Agenda Item # 2 SUB-002658-2023

The Resubdivision of Southern Oaks Subdivision

Proposal:

- Subdivision approval to create three (3) legal lots of record from two (2) legal lots of record.

DETAIL SITE PLAN

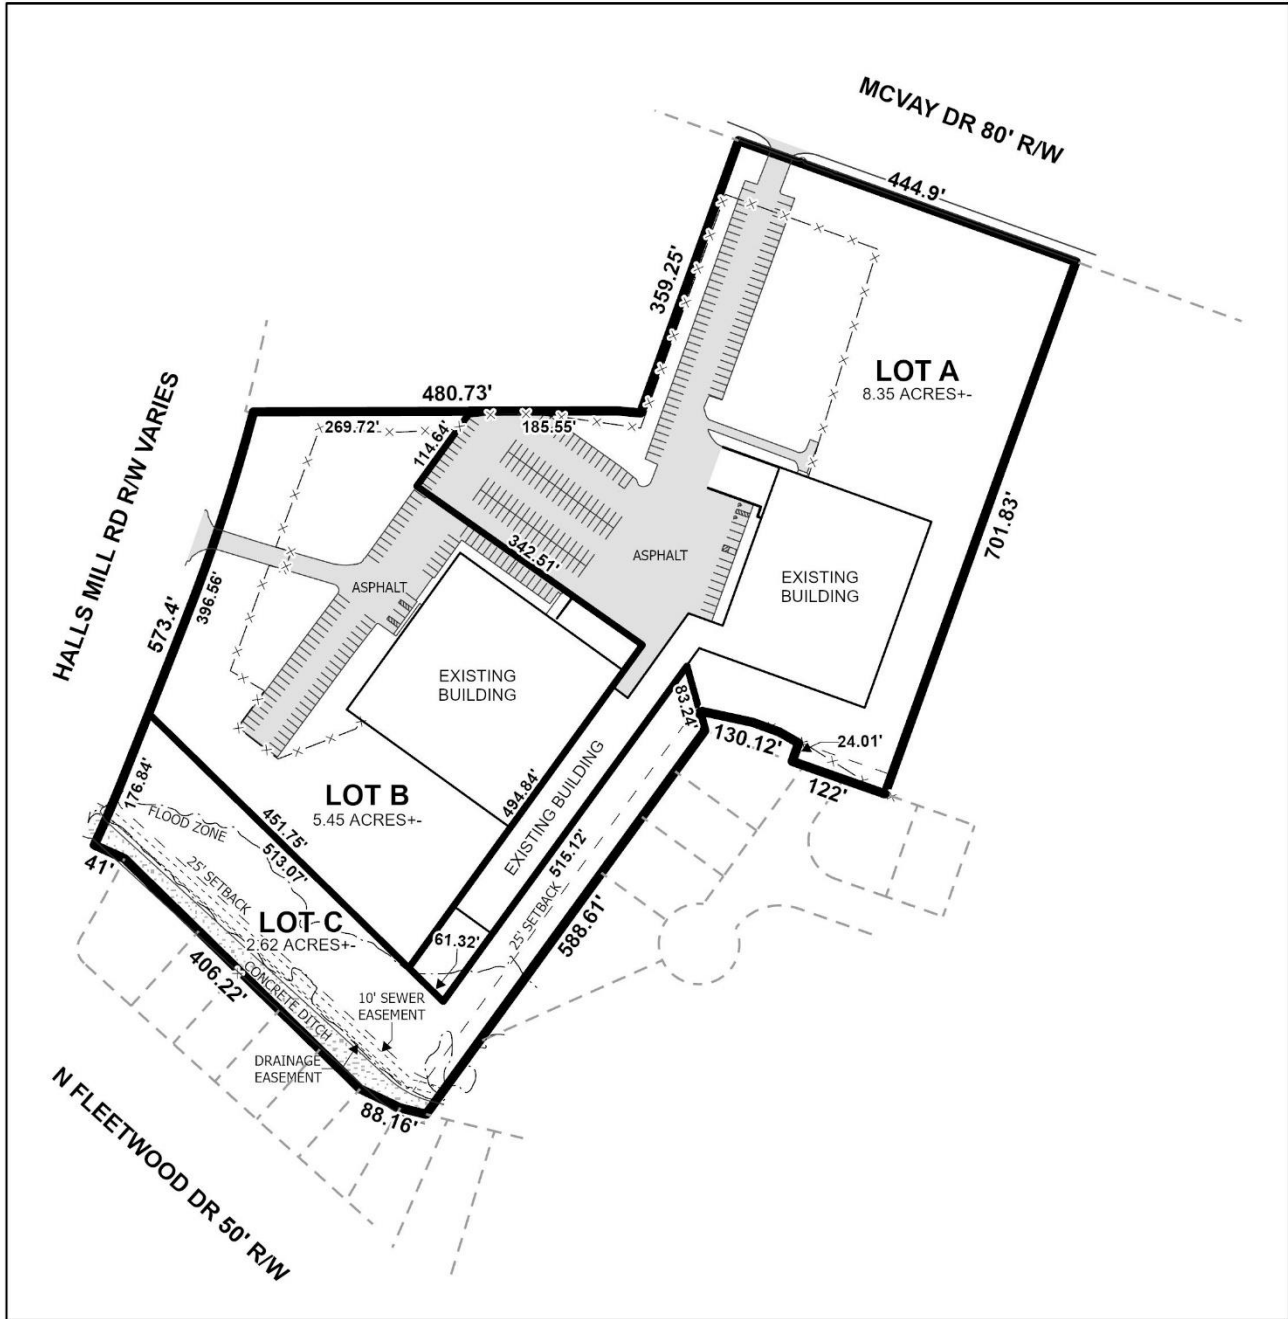
Proposed Lot A has frontage along McVay Drive North, a Minor Arterial street with an 80-foot right-of-way at this location. Proposed Lots B and C have frontage along Halls Mill Road, a Minor Arterial street requiring a 70-foot right-of-way at this location. The preliminary plat depicts adequate right-of-way along McVay Drive North and a varying right-of-way along Halls Mill Road. The Southern Oaks Subdivision plat, approved by the Planning Commission at its December 21, 2000 meeting and recorded in 2001, dedicated the required right-of-way along Halls Mill Road, thus no additional dedication is required; however, if approved, the Final Plat should be revised to depict the existing right-of-way along Halls Mill Road.

It should also be noted that McVay Drive North is inaccurately labeled "McVay Drive". If approved, the Final Plat should be revised to correctly label McVay Drive North.

Each lot, as proposed, exceeds the minimum size requirements for lots served by public water and sanitary sewer in both the B-2 and B-3 zoning districts. Their sizes are appropriately labeled in square feet and acres on the preliminary plat. If approved, this information should be retained on the Final Plat; or, provision of a table on the Final Plat with the same information will suffice.

Each proposed lot is irregularly shaped, and the depth of Lot C exceeds its width by more than 3.5, which is discouraged by Section 6.C.3 of the Subdivision Regulations. Such lot designs are not uncommon within the vicinity of the subject site, and previous subdivision approvals of the site with similar lot designs may again justify their approval. Previous approval of Lot C with nearly the same configuration may also justify an additional waiver of Section 6.C.3. regarding the excessive width-to-depth ratio of Lot C.

Lots A and B are proposed to share a common lot line through an existing building, and through part of an existing parking lot. The resulting setbacks of the building on each lot should not be an issue considering Section 64-2-14.E. of the UDC allows for either a zero-foot, or a five (5)-foot side and rear yard setback for lots in the B-3 zoning district; however, shared access to the parking lot should be facilitated via the appropriate legal instrument (e.g. ingress/egress easement, reciprocal easement, etc.), which has not been presented to Staff, and is not illustrated on the preliminary plat. As such, submission of a copy of the appropriate legal instrument facilitating shared access between Lots A and B should be required, prior to Staff signing the Final Plat; or, revision of the Final Plat illustrating an easement granting shared access may suffice.

If approved, the Final Plat should be revised to illustrate the 25-foot minimum building setback along each street frontage, per Sections 64-2-13.E. and 64-2-14.E. of the UDC for lots in the B-2 and B-3 zoning districts within the Suburban sub-district.
